**ACTION TRANSMITTAL No. 2014-43**

**DATE:** June 6, 2014  
**TO:** TAC-Planning Committee  
**FROM:** City of Eden Prairie  
**PREPARED BY:** Bob Paddock  
**SUBJECT:** Roadway Functional Classification Changes – Eden Prairie  
**REQUESTED ACTION:** The City of Eden Prairie requests that the TAC-Planning Committee approve the following roadway functional classification changes.  
**RECOMMENDED MOTION:** That the TAC-Planning Committee move approval of the following changes and forward them to the TAC, recommending approval.

# Regional Functional Classification Change Request Form

# Functional Class Roads Change Requests Eden Prairie

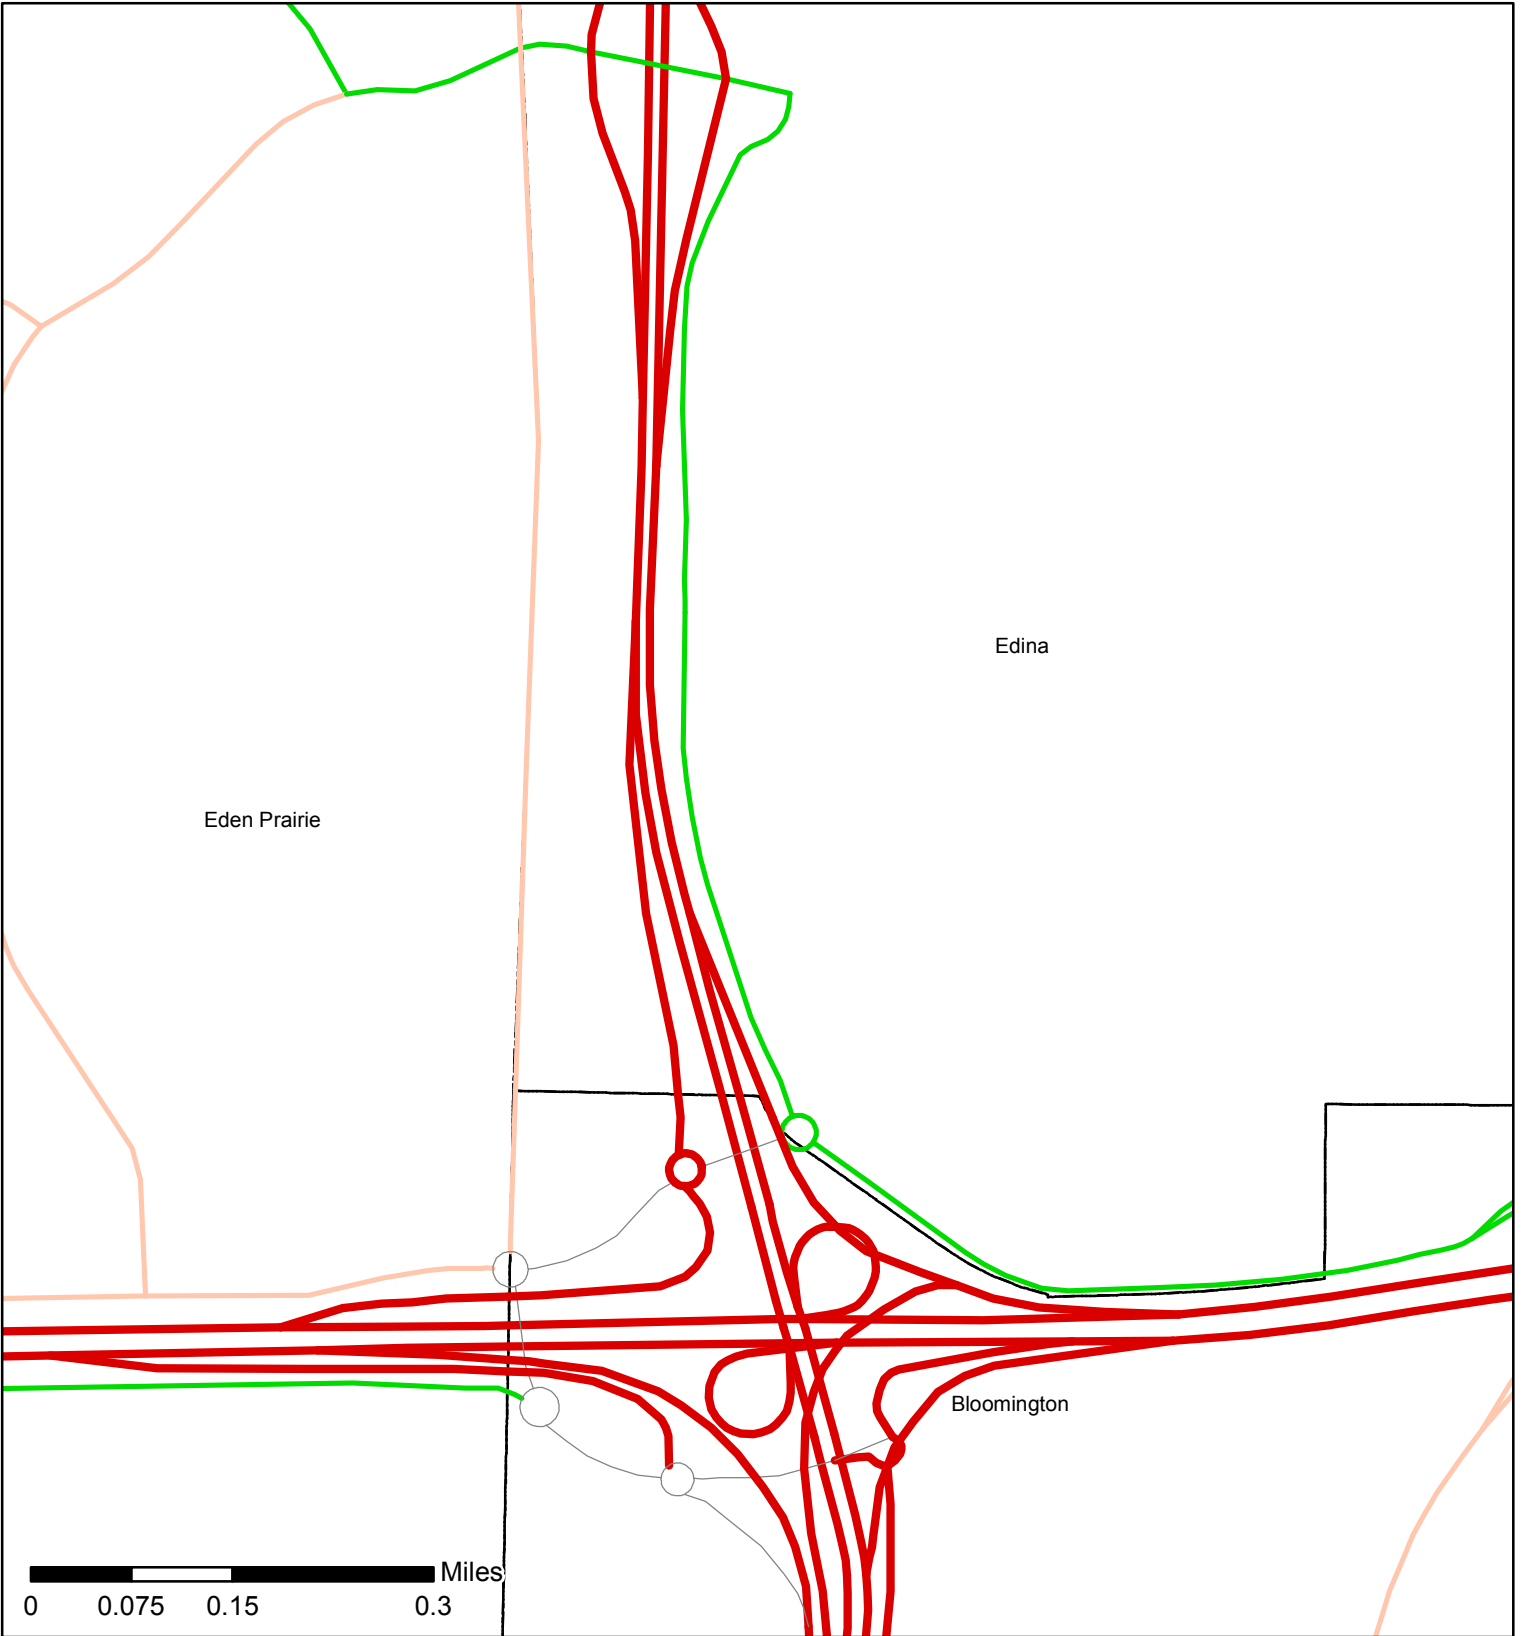
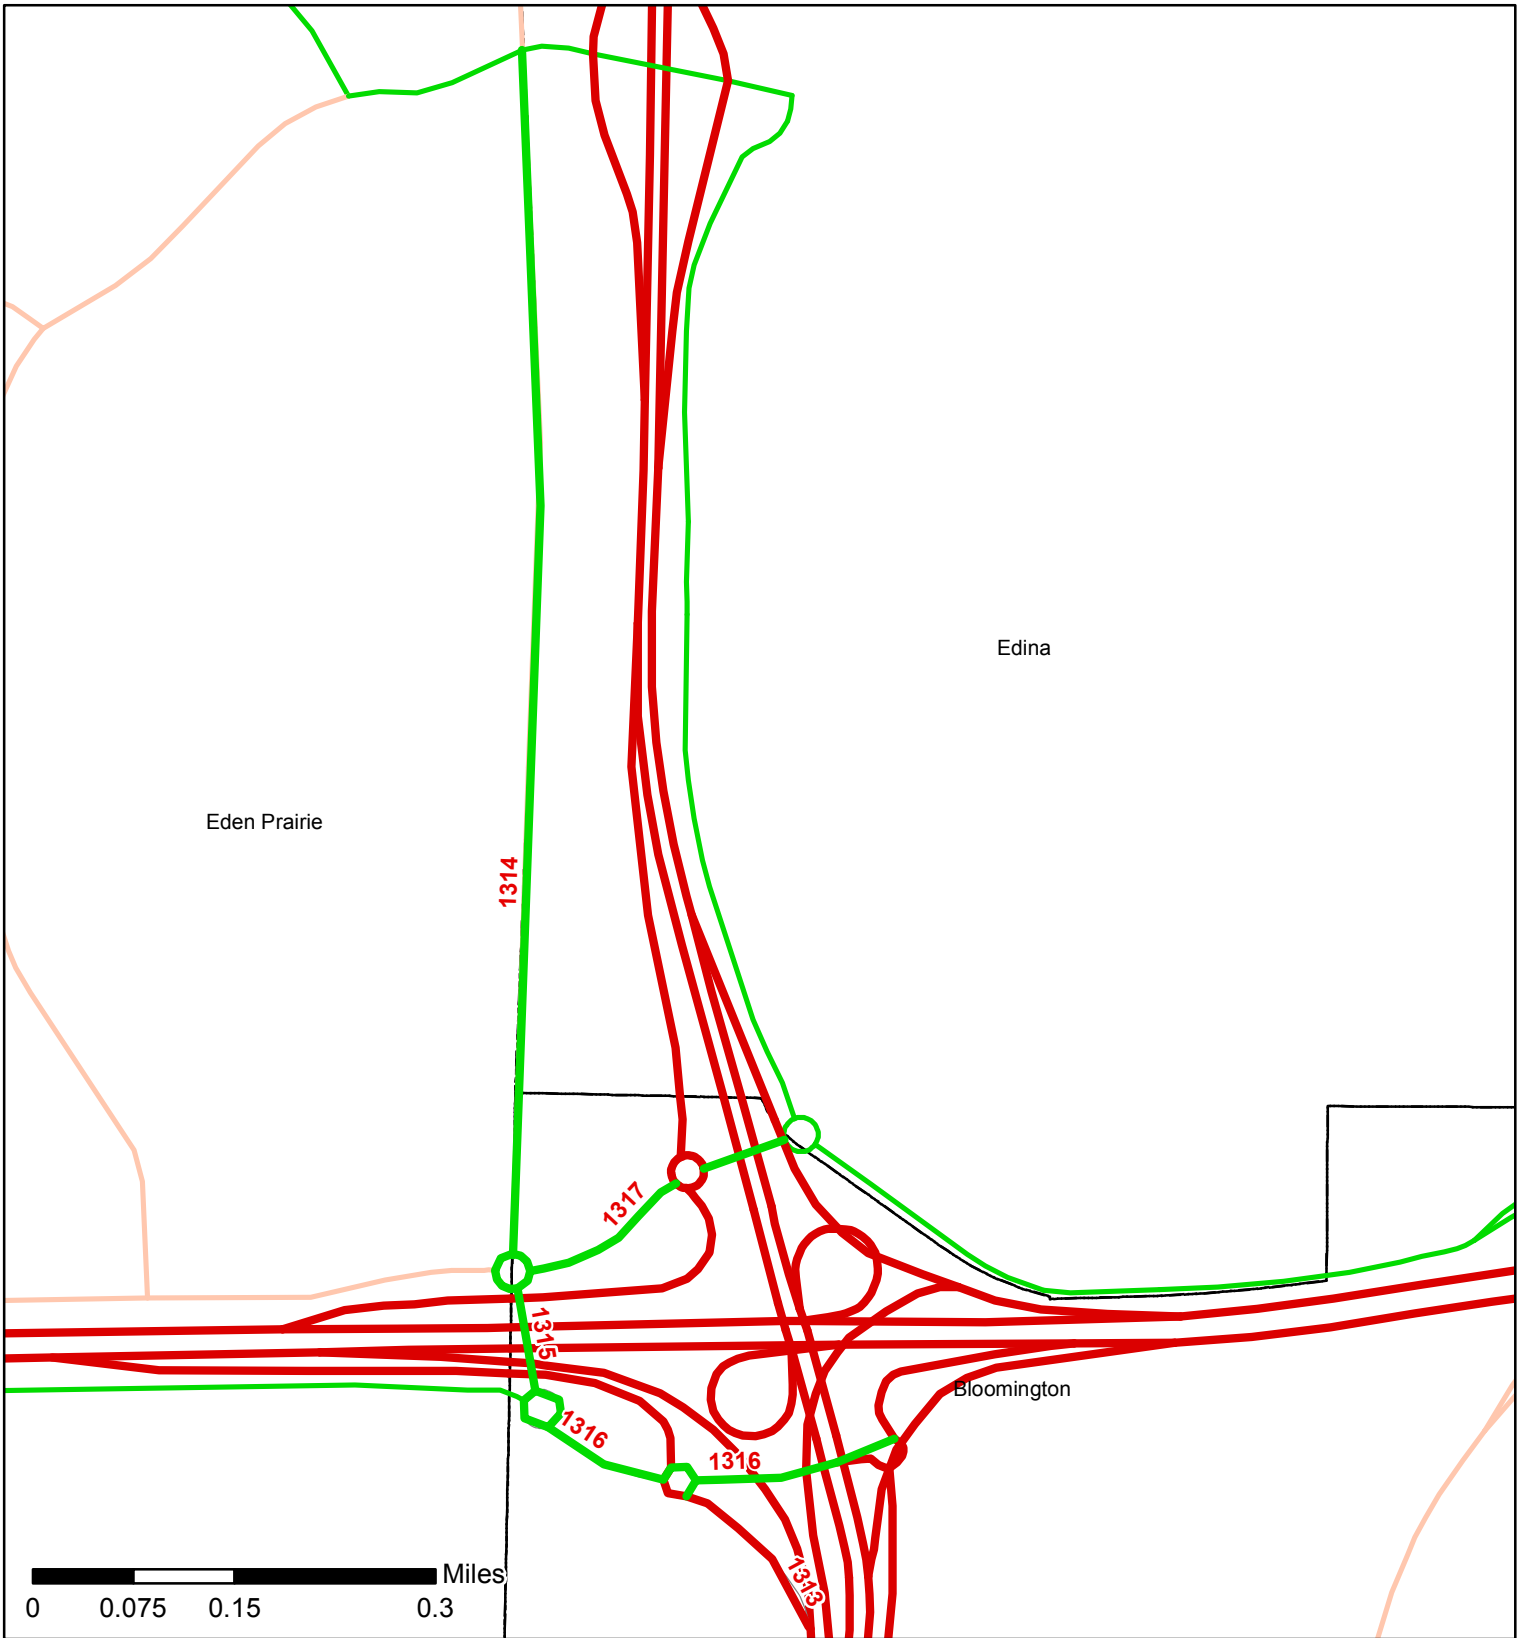
**#1313** - TH169 Southbound Ramp from Washington Avenue be classified as a Principal Arterial.

**#1314** – Washington Avenue from Viking Drive/West 78<sup>th</sup> Street to Valley View Road be reclassified from a Major Collector to an A-Minor Reliever Arterial.

**#1315** – Washington Avenue from West 78<sup>th</sup> Street (south Junction) to West 78<sup>th</sup> Street (North Junction)/Viking Drive be classified as an A-Minor Reliever Arterial.

**#1316** – Washington Avenue / Marth Road from West 78<sup>th</sup> Street (South Junction) to the TH 169 Northbound Off Ramp be classified as an A-Minor Reliever Arterial.

**#1317** – West 78<sup>th</sup> Street from Viking Drive to TH 169 East Frontage Road be classified as an A-Minor Reliever Arterial.

**STAFF ANALYSIS:** Staff reviewed the request and agreed that these changes were sensible. Staff recommends approval. It should be noted that the Principal Arterial designation requested for the entrance ramp is simply a 'technical correction' and does not require TAB approval, since all ramps to the Principal Arterial system are thus designated.
